Proposed Social Welfare Facilities (Residential Care Home for the Elderly (RCHE)) in "Village Type Development" Zone, Lots 3670 RP (Part), 3671 RP (Part), 3672 RP (Part), 3673 RP (Part) and adjoining Government Land in D.D.104, Nam Sang Wai, Yuen Long (TPB ref.: A/YL-NSW/349)

Response-to-Comment Table

FIGURE 3.1 LOCATION OF REPRESENTATIVE NOISE SENSITIVE RECEIVERS

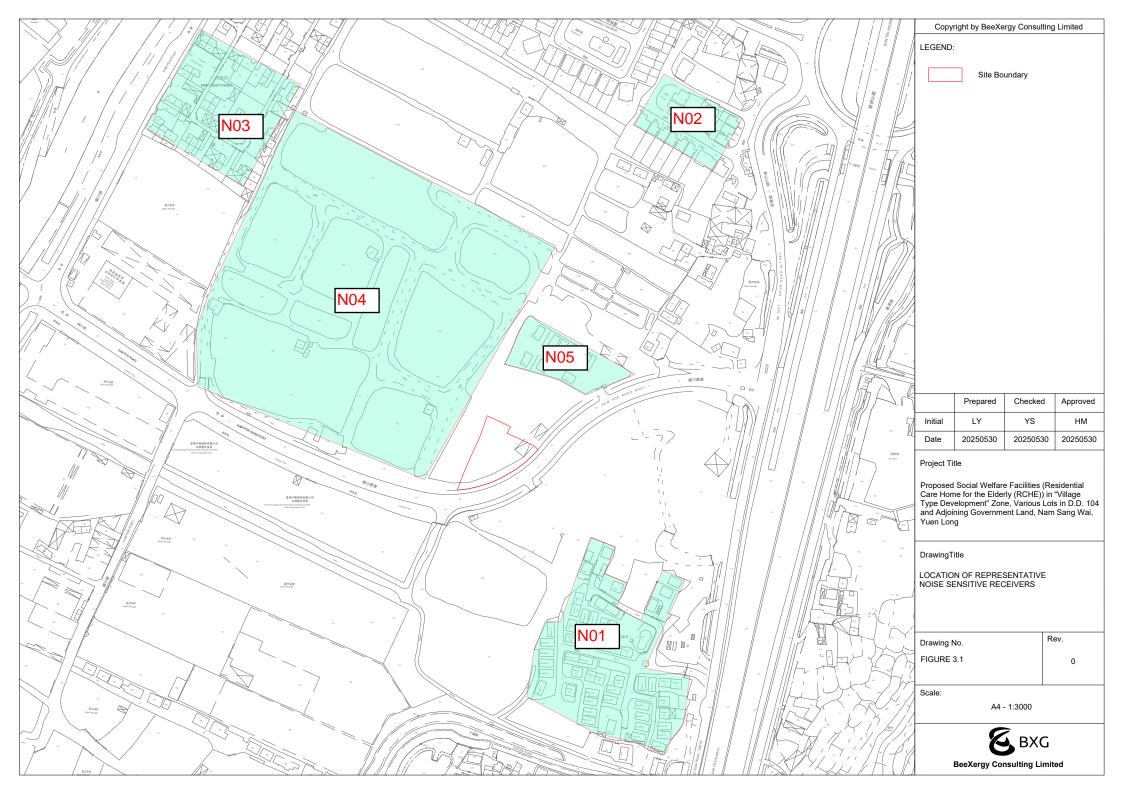
1. Please review whether the structures in the immediate north of the Site are NSRs.	New NSR is added in Table 3.5 and Figure 3.1.	
2. Last RtC item 3 - Noted that the endorsement of the traffic forecast	Noted, the endorsement of the traffic forecast by TD will be provided once	
by TD is to be provided. In case TD has no comment on the	available.	
methodology for traffic forecast only, the consultant should		
provide written confirmation from the respective competent party		
(e.g., traffic consultant) that TD's endorsed methodology has been		
strictly adopted in preparing the traffic forecast data, and hence		
the validity of traffic data can be confirmed.

FIGURE 3.4 LOCATION OF BACKGROUND NOISE MEASUREMENT AND MAJOR FIXED NOISE SOURCES

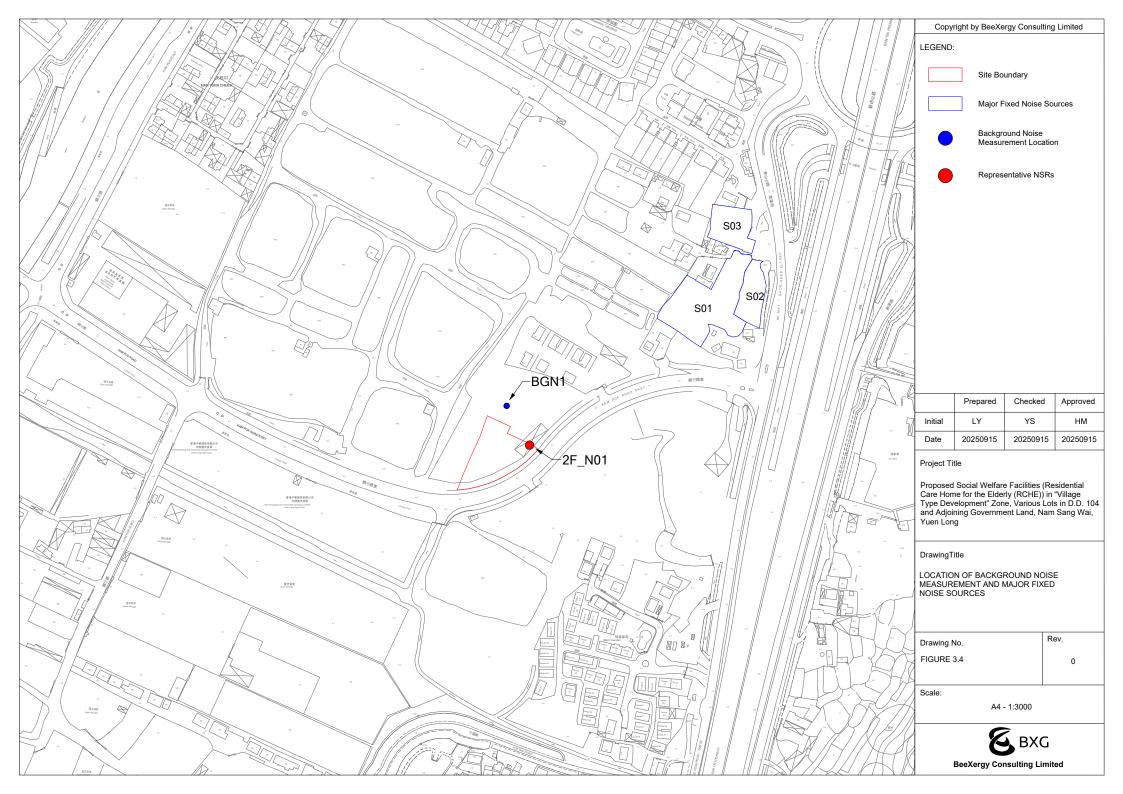
i. There is a fixed noise assessment point located at 2F_N01, as indicated in	The Figure is updated accordingly.	
Appendix 3.4. Please include the corresponding fixed noise assessment point		
in Figure 3.4.		
ii. Additionally, in the main text section S3.4.23 or any where appropriate,	The explanation is provided in S3.4.23.	
please provide an explanation for the selection of this fixed noise assessment		
point. It should be clarified if this point was chosen due to it being the most		
affected direction / the shortest distance to the noise sources.		
iii. Please also provide the calculation excel sheet for our checking.	Noted.

FIGURE 6.1 AERIAL PHOTOS

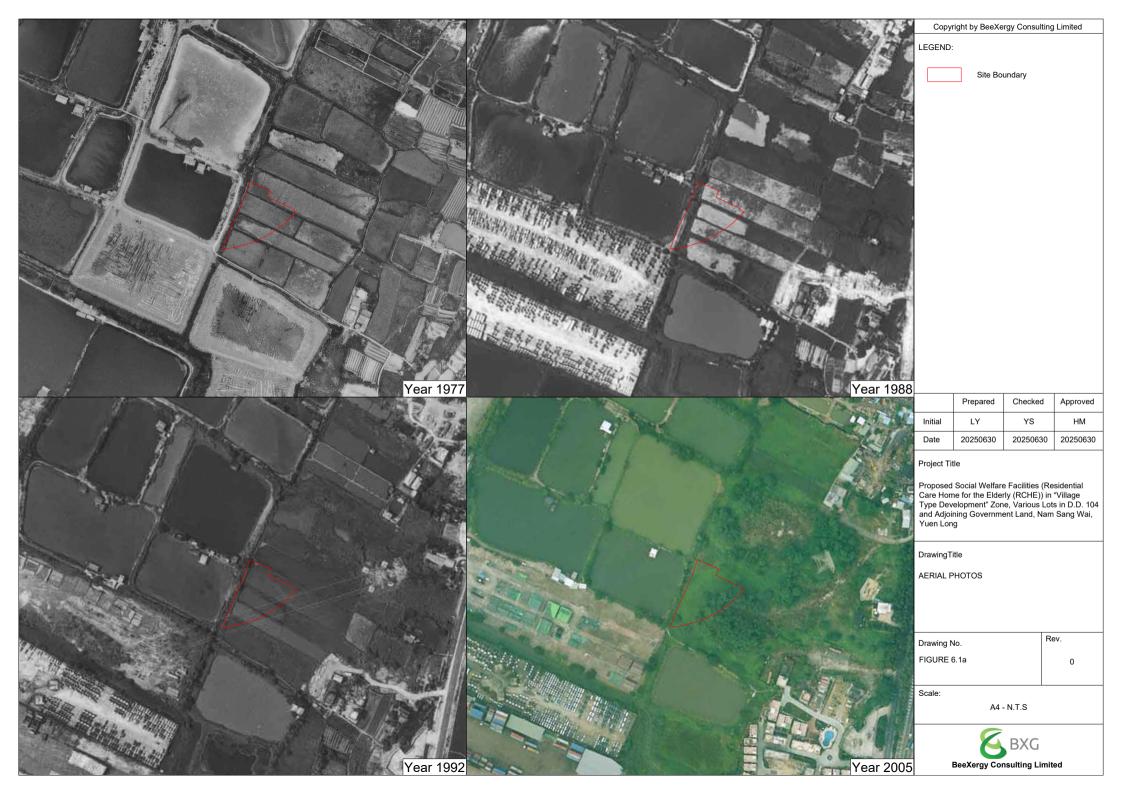
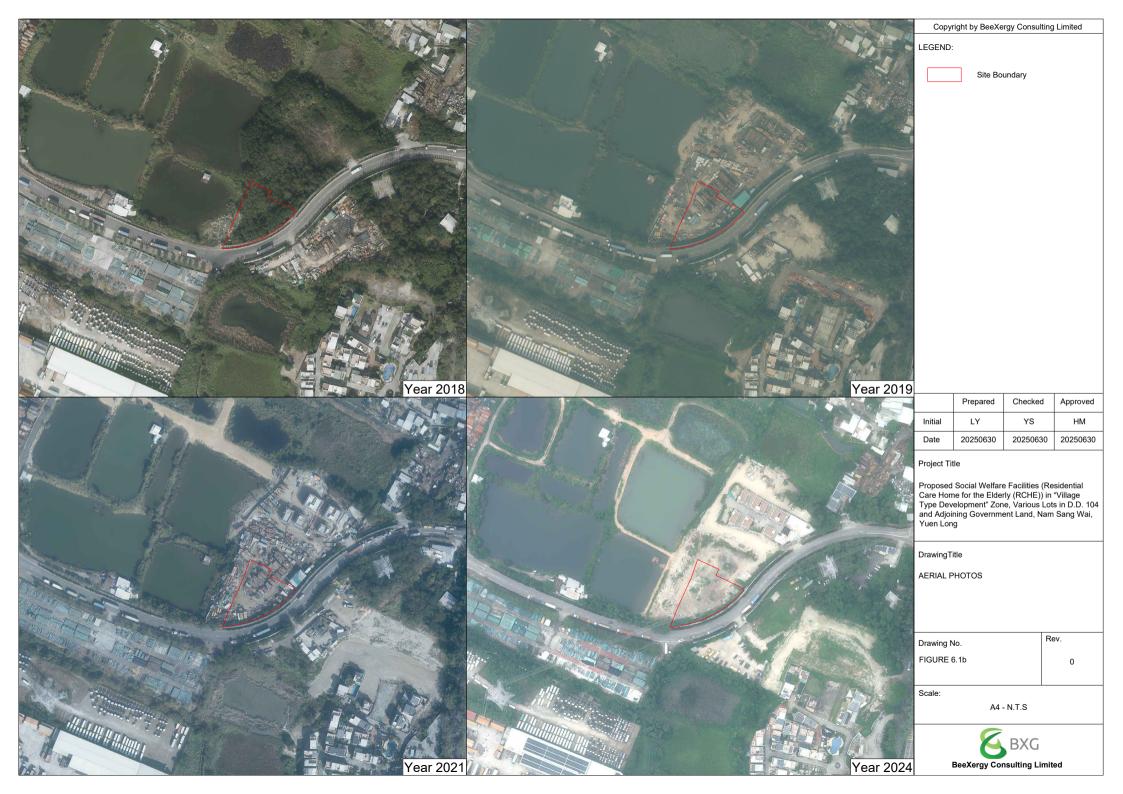
persons.			
Land Contamination			
1. 6.4.2 Please avoid describing unpaved areas as having "good			
ground condition." Elaborate on whether the presence of			
metal/steel, casings, and other stored goods observed in aerial			
photos could indicate potential land contamination risks.

Modification Plans of Noise Barrier and Street Furniture

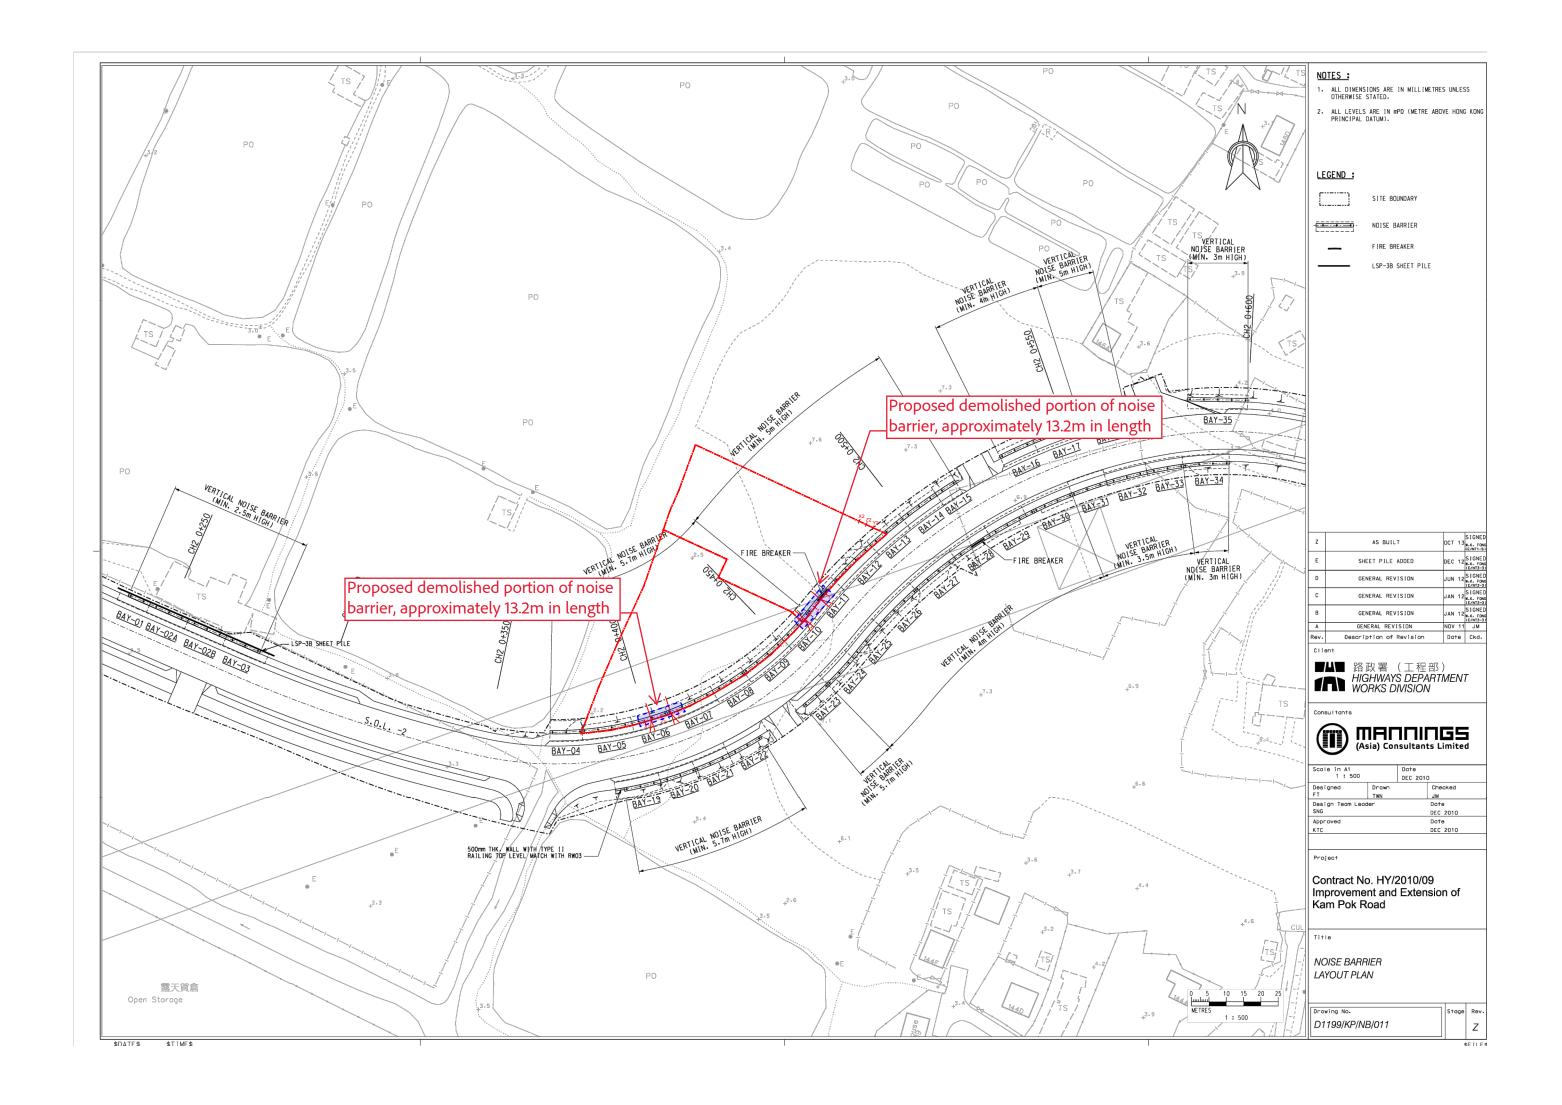
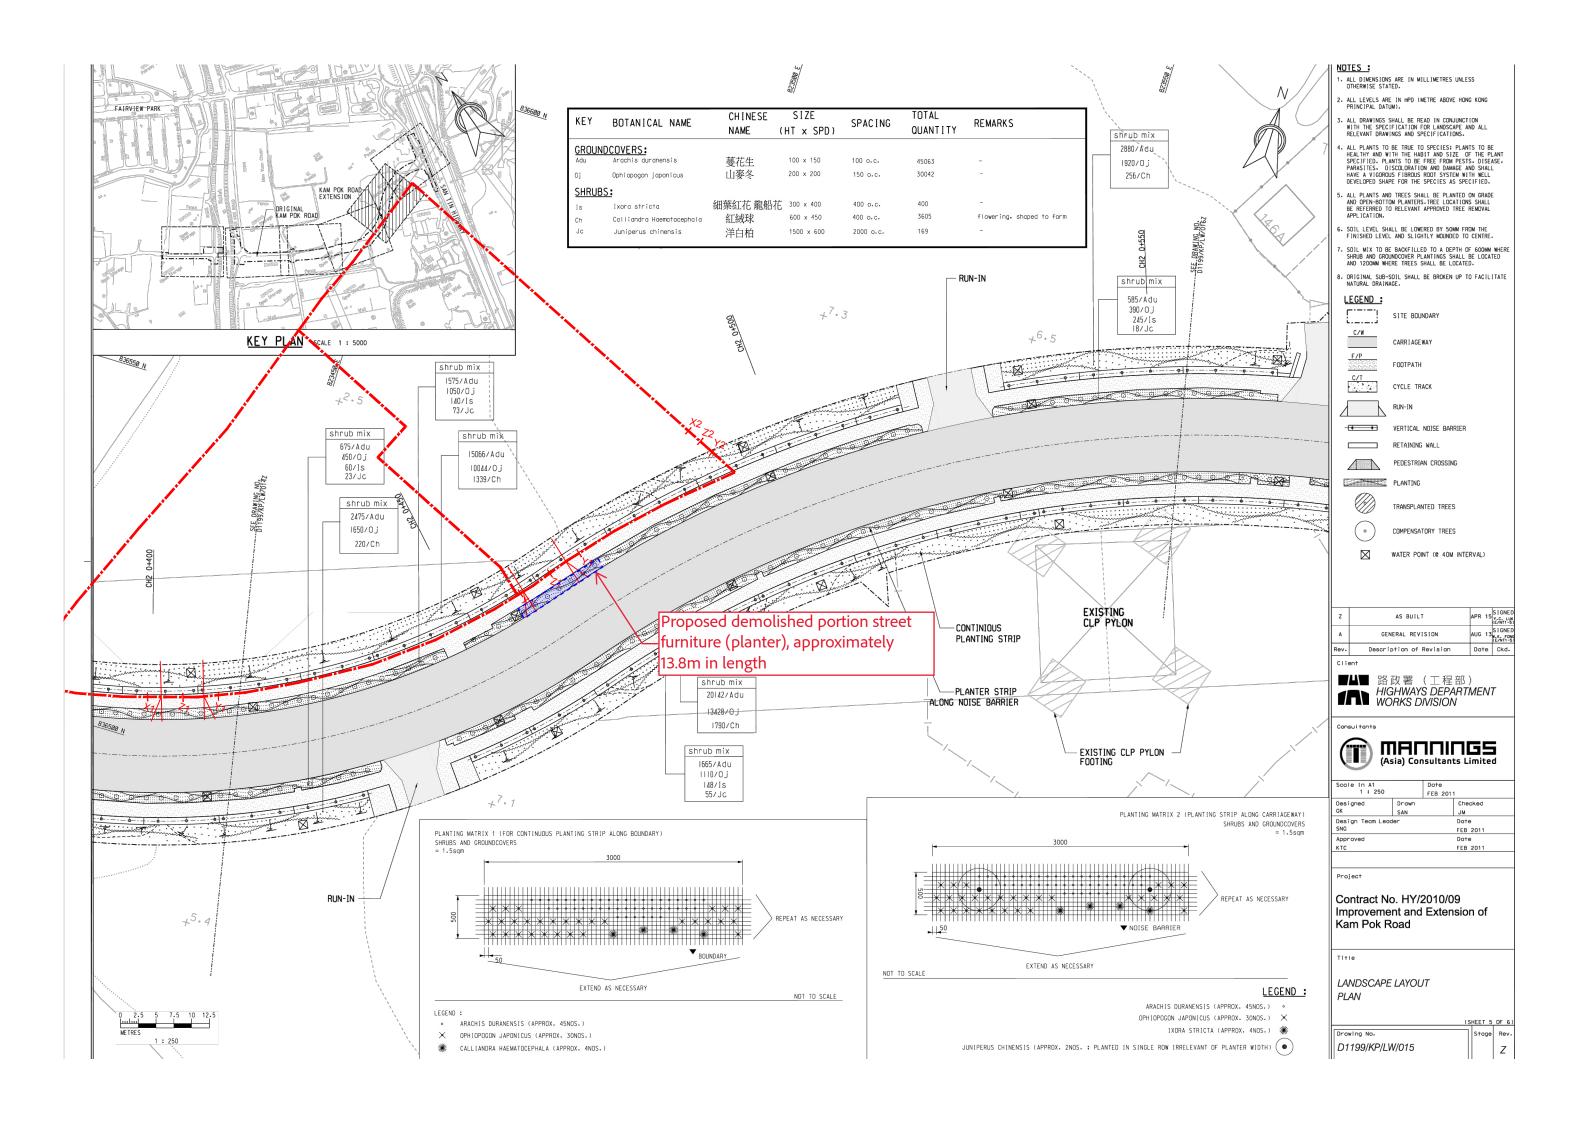
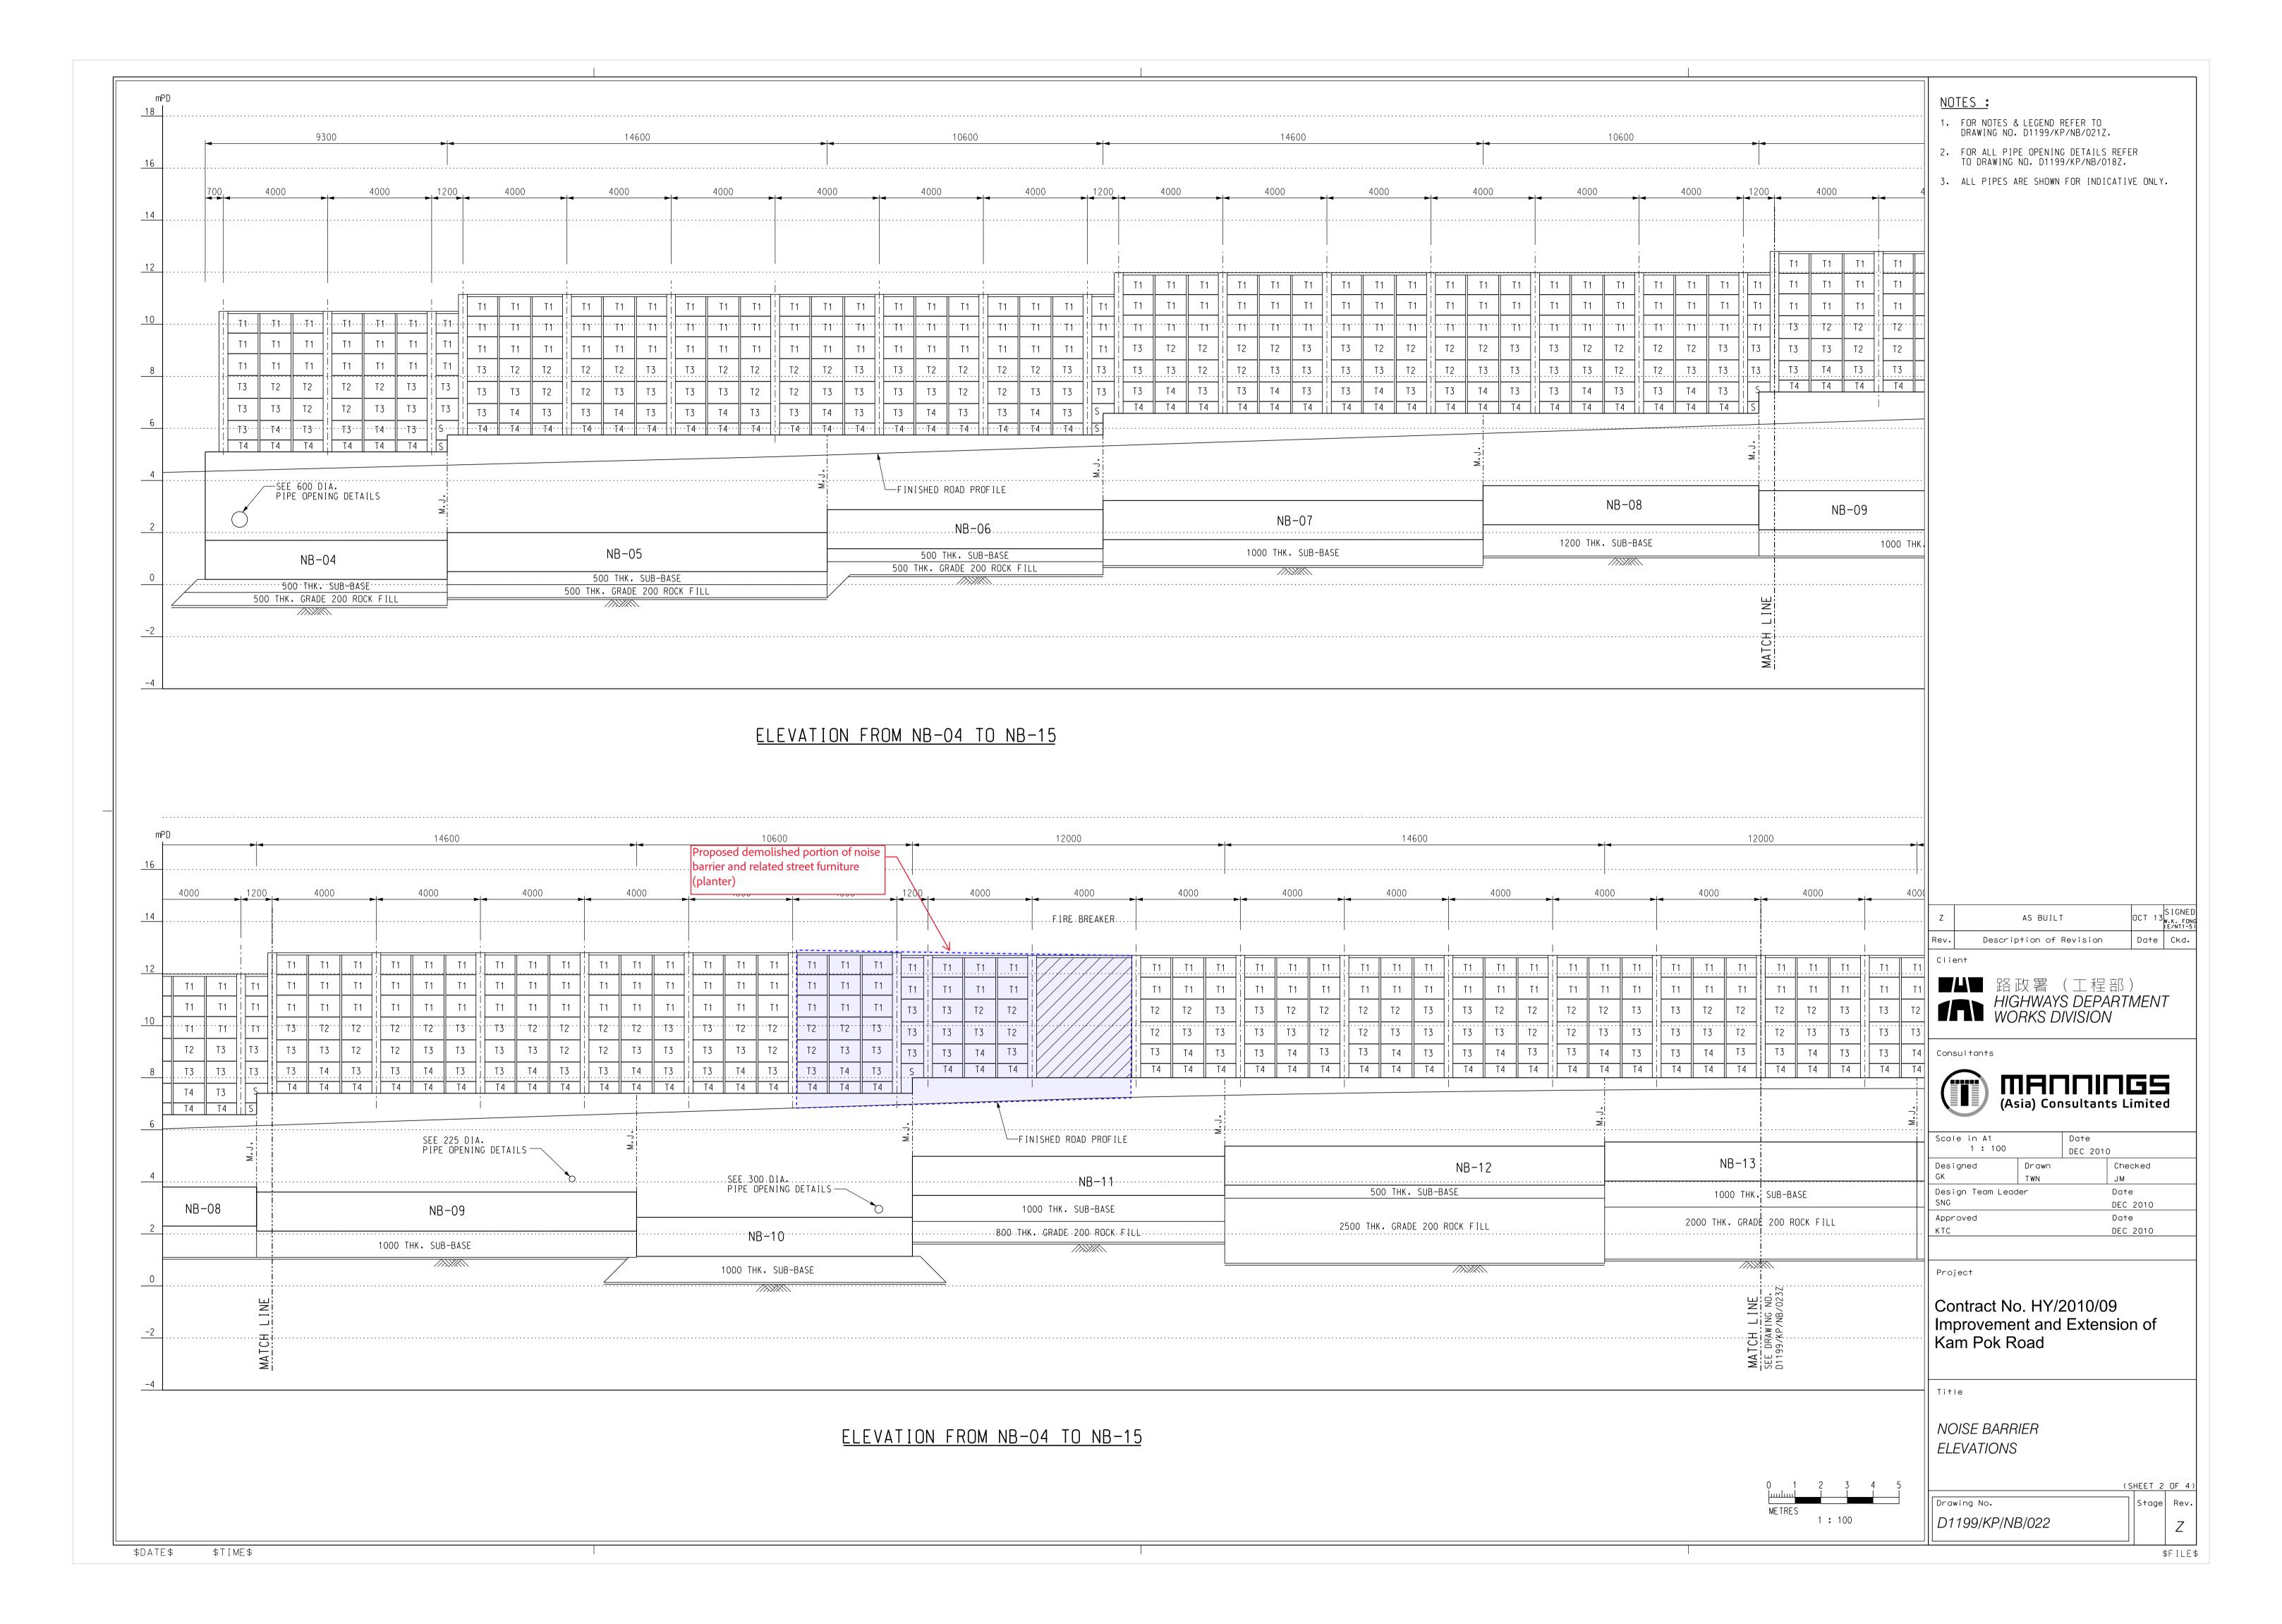
(a) The relevant portions of noise barriers proposed to be removed have not been clearly indicated or marked on the modification plan. Please clarify.	Please refer to Appendix 1 for the Modification Plans of Noise Barrier and Street Furniture.

(c) Please clarify whether the noise implications due to the deletion or removal of existing noise barriers have been assessed in the noise impact assessment, and agreed by EPD. Presumably, the Transport Department would comment on the traffic data adopted for the noise
